93-RF-7137

OPERABLE UNIT NO. 5 (OU 5), MONITORING WELL LOCATIONS - IHSS 115 - ORIGINAL
LANDFILL - WSB-282-93

PROPOSED MONITORING WELL LOCATION MAP

IHSS 115 ORIGINAL LANDFILL MONITORING WELL INSTALLATION PLAN

FIGURE 4

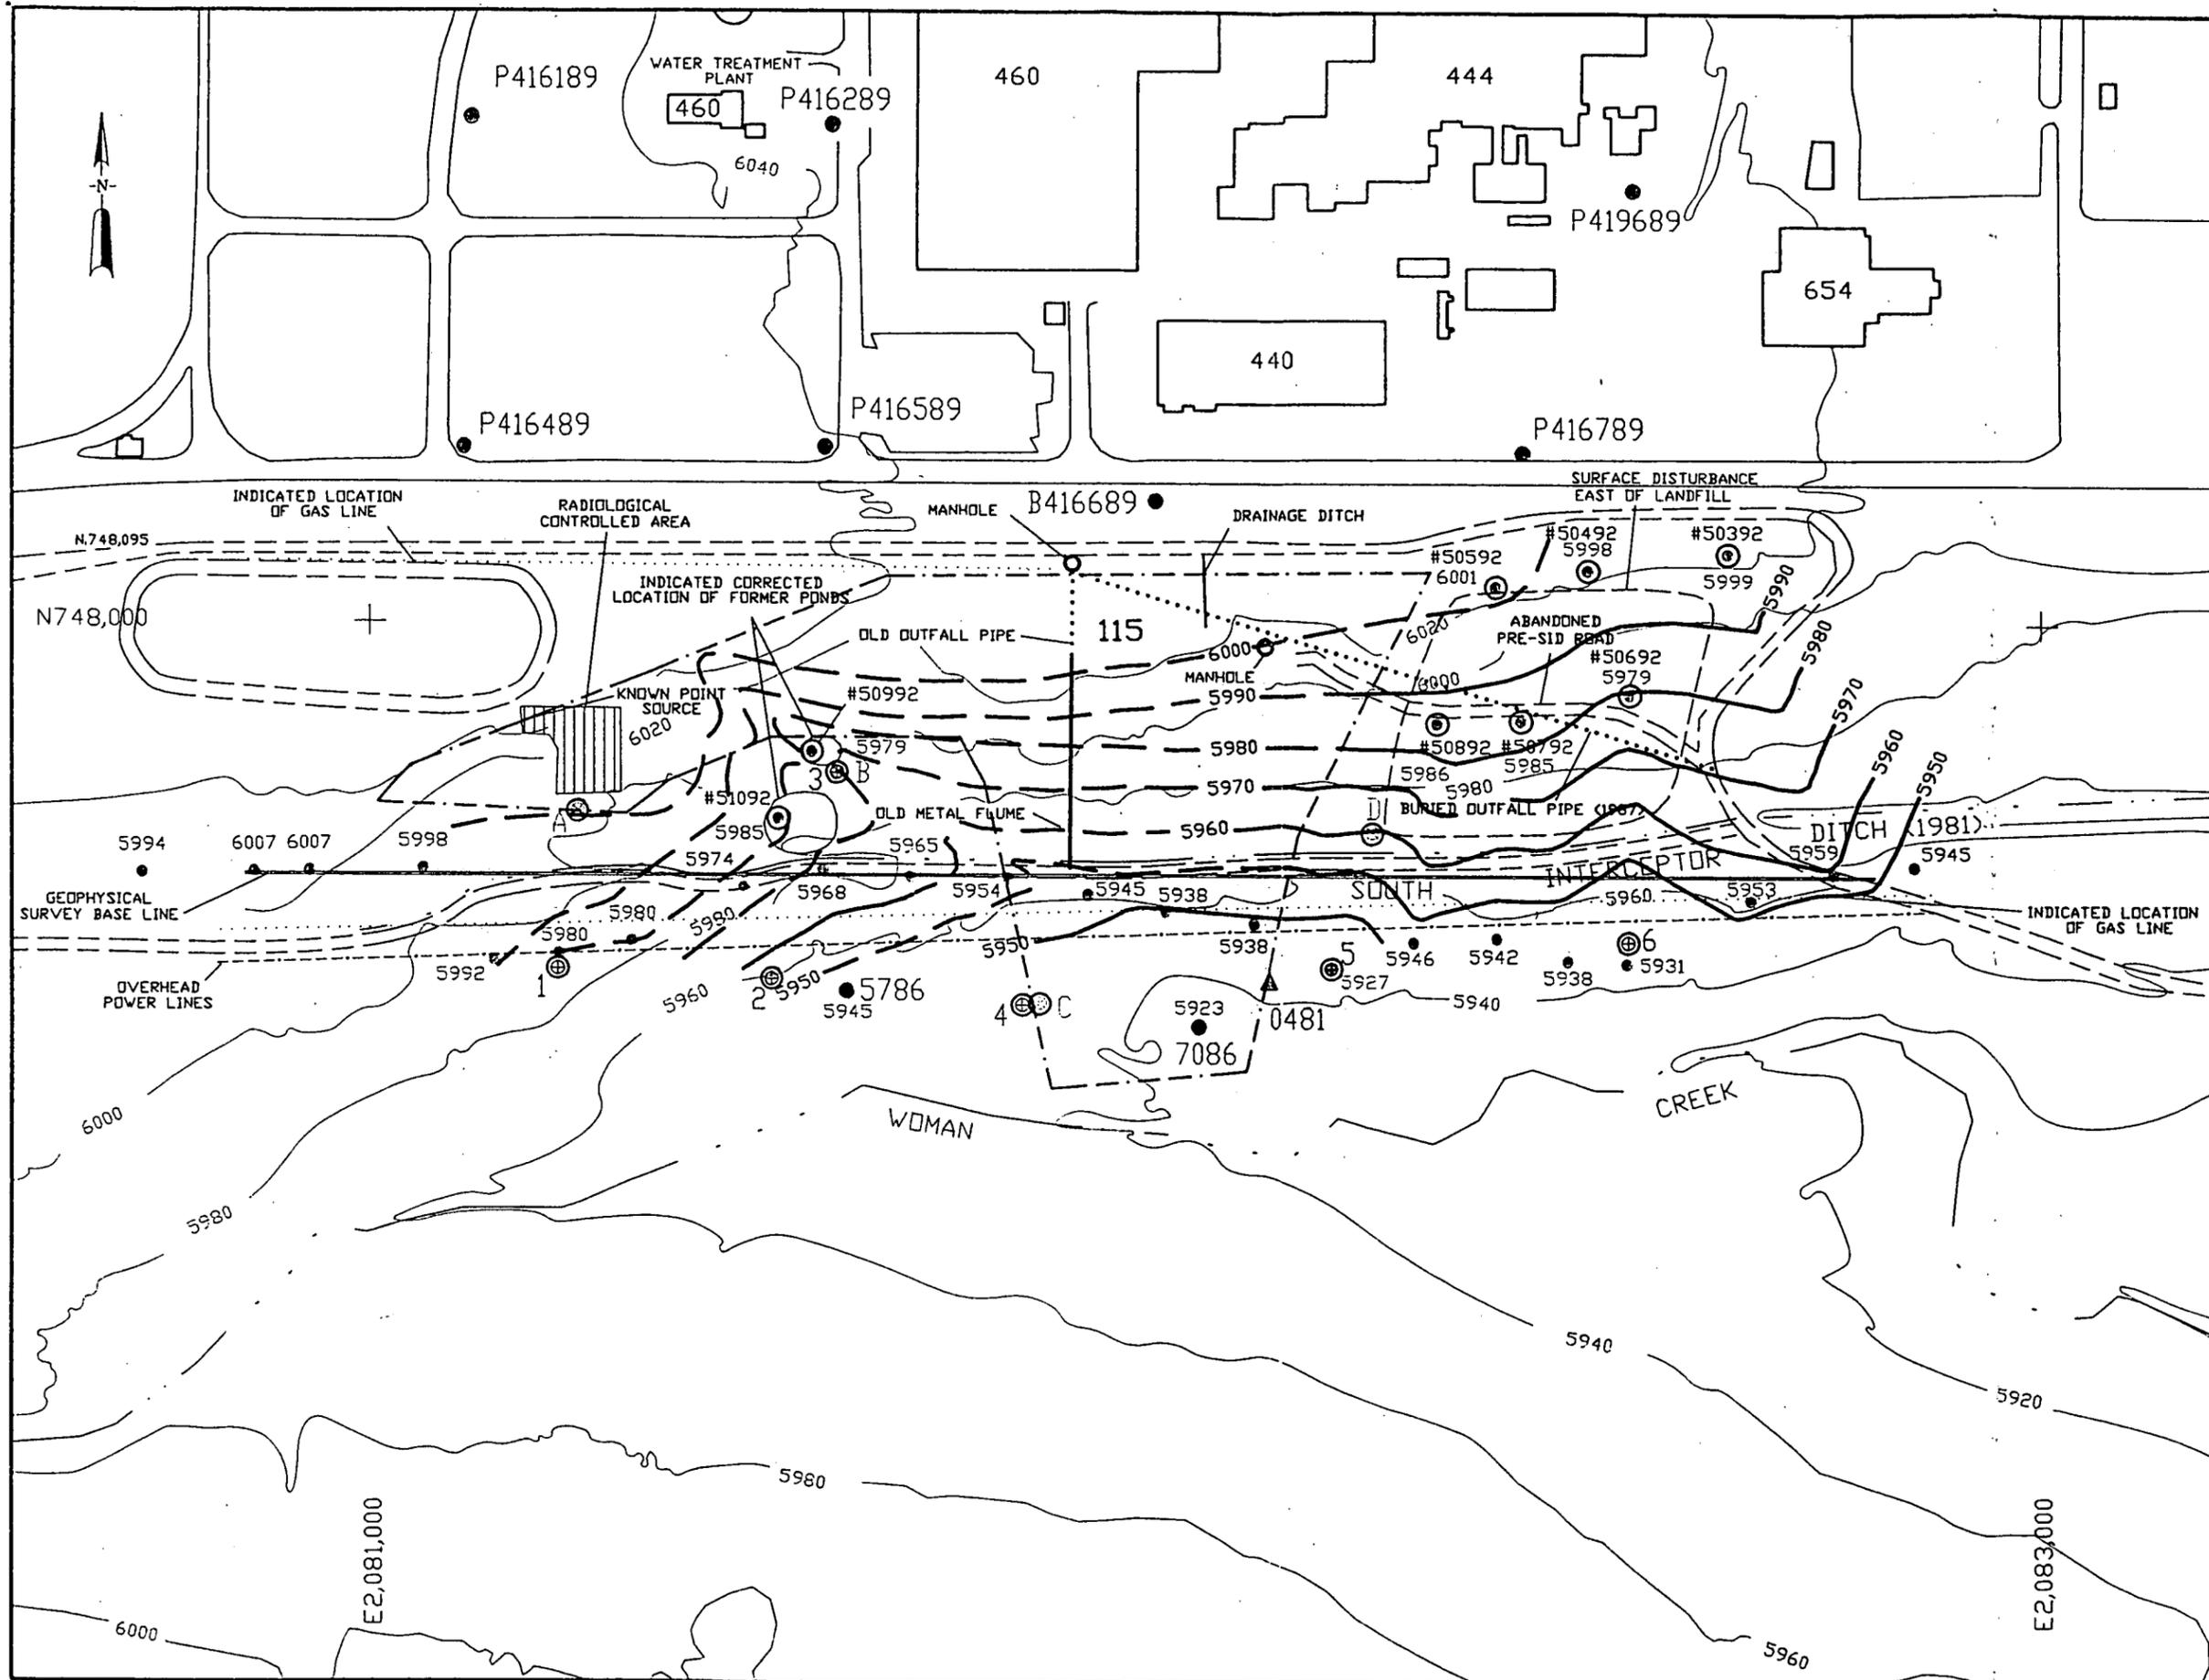
This proposed well location has been renamed well location 3; no other adjustment has been made. Groundwater was present in borehole #50993 but was not sampled at the time of drilling. This proposed well location is located in what appears to be a channel incised in bedrock (Figure 4).

Well location D has been moved approximately 150 feet to the south and renamed well location 5. This places the well south of the SID and downgradient of the Landfill. This also places the well in an area that overlies a bedrock low (Figure 3), where groundwater is present in the alluvium as indicated by the CPT survey at location 05993, and in a probable channel incised in bedrock (Figure 4).

This new well location is proposed in order to have a well downgradient of the eastern end of the Landfill. The well is proposed to be located at CPT location 05593 because the CPT survey indicated an underlying bedrock low (Figures 3 and 4). A visual review of the ground surface in this area reveals two seeps to the north of the location that is probably evidence of groundwater.
